Town Planning Application No. A/YL-NSW/349 - Submission of Further Information (5)

**PROPOSED SOCIAL WELFARE FACILITIES (RESIDENTIAL CARE HOME FOR THE ELDERLY (RCHE)) IN “VILLAGE TYPE DEVELOPMENT”
ZONE, VARIOUS LOTS IN D.D. 104 AND ADJOINING GOVERNMENT LAND, NAM SANG WAI, YUEN LONG
(APPLICATION NO. A/YL-NSW/349)**

SEWERAGE IMPACT ASSESSMENT

Report No: RT25285-SIA-01D

FIGURE 3
PROPOSED TERMINAL MANHOLE AND
CONNECTION

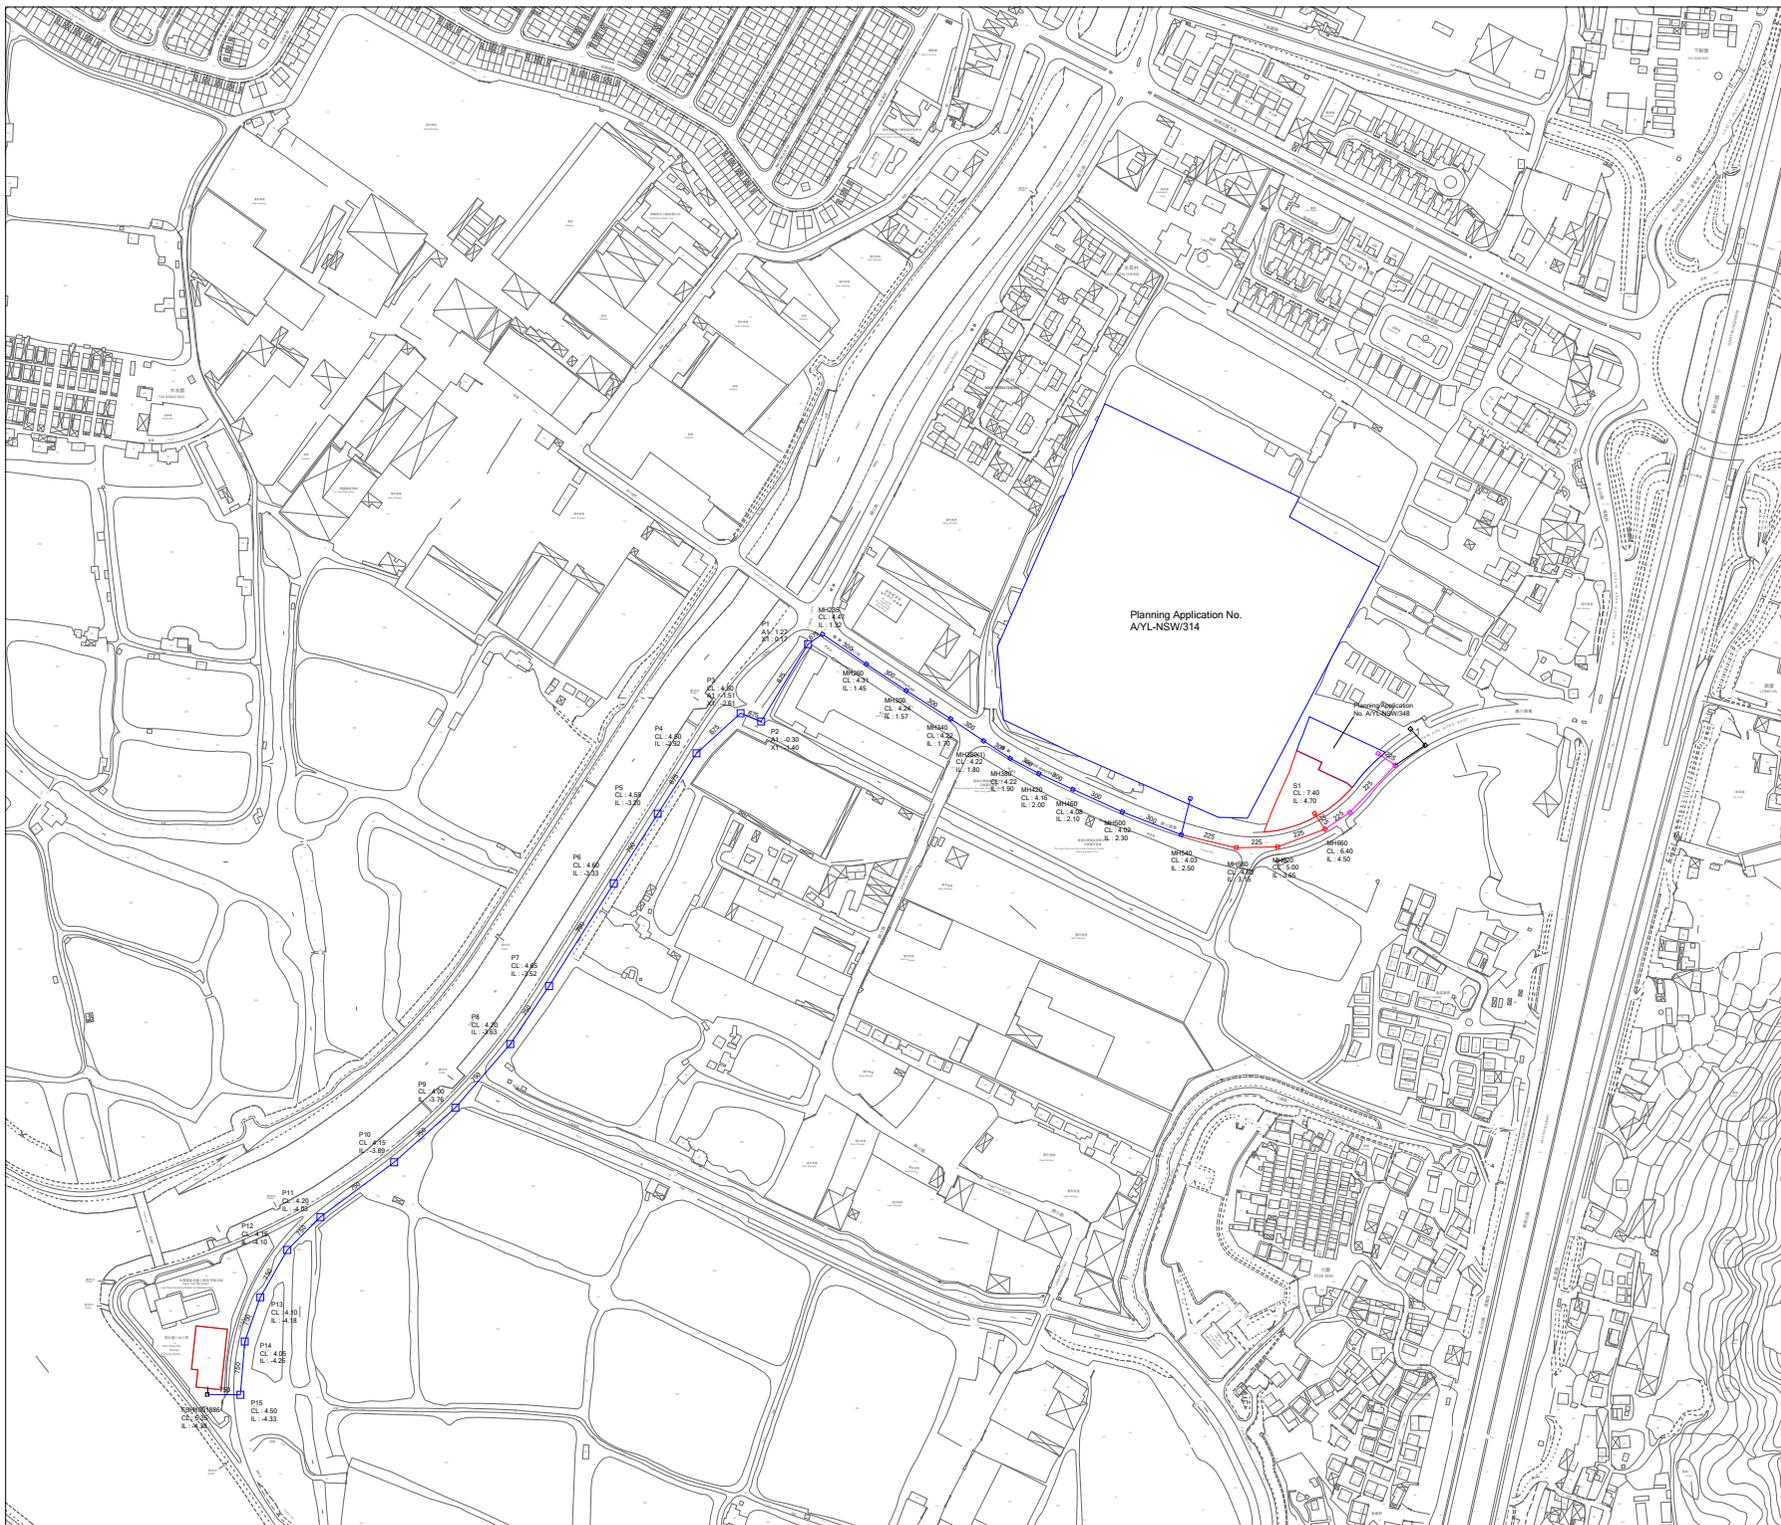
2. Sections 2.3-2.5: The applicant should clarify the party who is responsible for implementation of the proposed sewerage facilities connecting manholes S1 and MH540.	The discussion has been provided in Section 2.4-2.5.

- 2.4.1. New terminal manhole (namely S1) and manholes MH660, MH620 and MH580 will be constructed to collect the sewage generated from the Proposed Development and connect to manhole MH540 via a new 225mm diameter sewer pipe. The location of the proposed connection are shown in **Figure 3**. The cover level of proposed terminal manhole should be higher than that of the downstream public manhole(s). The proposed new terminal manhole and 225mm sewer pipe within site boundary will be implemented and maintained by the Project Proponent, other proposed manhole and sewer outside site boundary will become a public sewage system serving multiple users and will be handed over to government for future maintenance. The capacity check of the sewer will start from the proposed terminal manhole S1. The proposed development would not have population intake before the sewerage infrastructure of the project is functionally connected to the public sewerage system by other development mentioned in Section 2.3.

- 2.4.3. The party responsible for construction of sewers from manhole S1 to FSH1001886 is summarized in **Table 2.1**.
